Product Change Notice (PCN)

Subject: Assembly & sorting factory addition for RL78/G13, RL78/G14 LQFP44pin package products.

Group name : RL78/G13、RL78/G14

Target package : 10mm×10mm 0.8mm pitch 44pin LQFP

DIFFERENCE OF SPECIFICATION

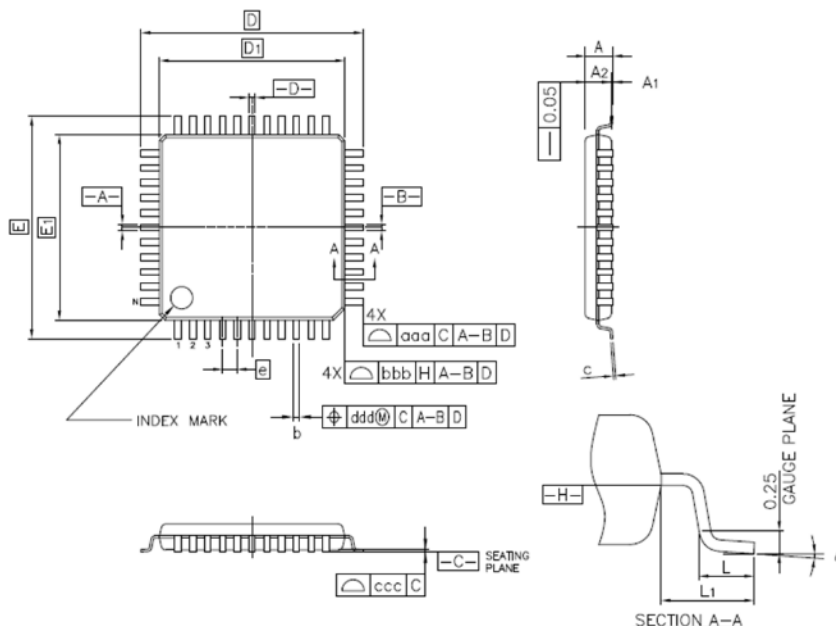
Item	Additional factory	Existing factory	Existing factory	Existing factory
Assembly factory	Beijing	KL	Greatek	ASEKH
Sorting factory	Beijing	KL	KYEC	Beijing or KYEC
Package	Outline	There are differences (Refer to the Package outline and the Dimension comparison)		
Lead frame	Material	No change		
	Inner pattern	There are differences (Refer to the Package structure image)		
Die mount	Material	Ag epoxy paste D *	Ag epoxy paste A *	Ag epoxy paste B *
Bonding wire	Material	No change: Cu (Pd coating)		
Resin	Material	Epoxy resin D * (halogen-free)	Epoxy resin A * (halogen-free)	Epoxy resin B * (halogen-free)
Plating	Material	No change		
Marking		There are differences (Refer to the Marking specification and the Marking photos)		
Packing	Tray/ Emboss tape	No change		
Storage conditions	after opening	30°C/70%RH/ within 168hr		30°C/60%RH/ within 168hr (JEDEC standard)

There are differences in materials, but there is no change in reliability or characteristics.

Package outline (Greatek)

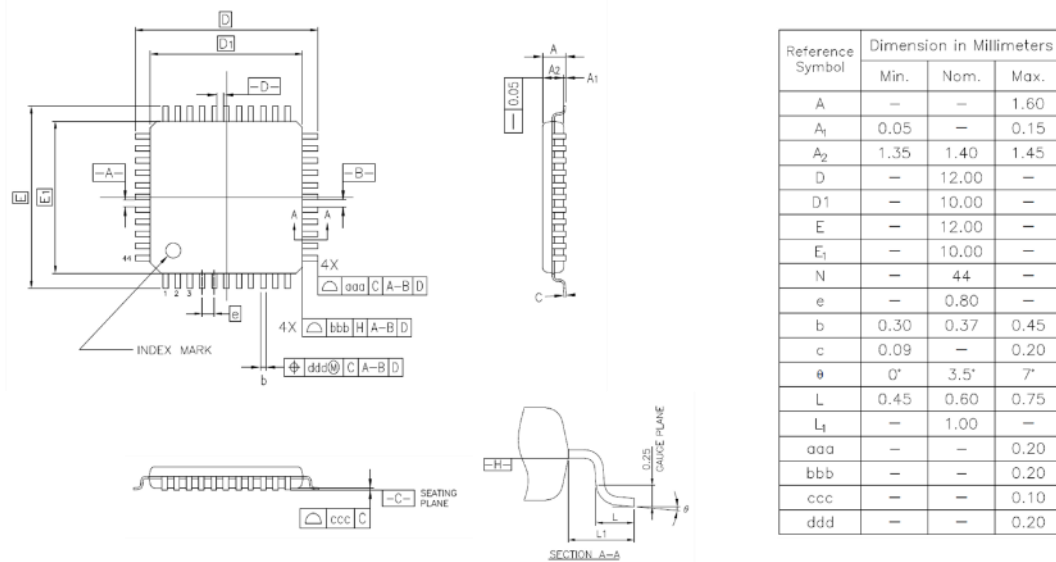
Refer to the “Appendix” for detail.
 There is no change in footprint for additional factory products.

Dimension comparison
